Product Change Notice (PCN)

PCN Number: PCN-0450092R-01

Product(s) Affected: PJ-003A, PJ-003B, PJ-003AH

Old version:

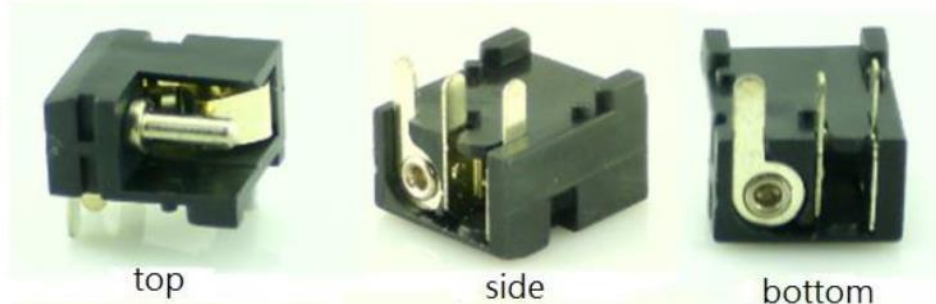
Description of Change: new mold design will adjust the appearance of the products. The electrical structure and function remain the same:
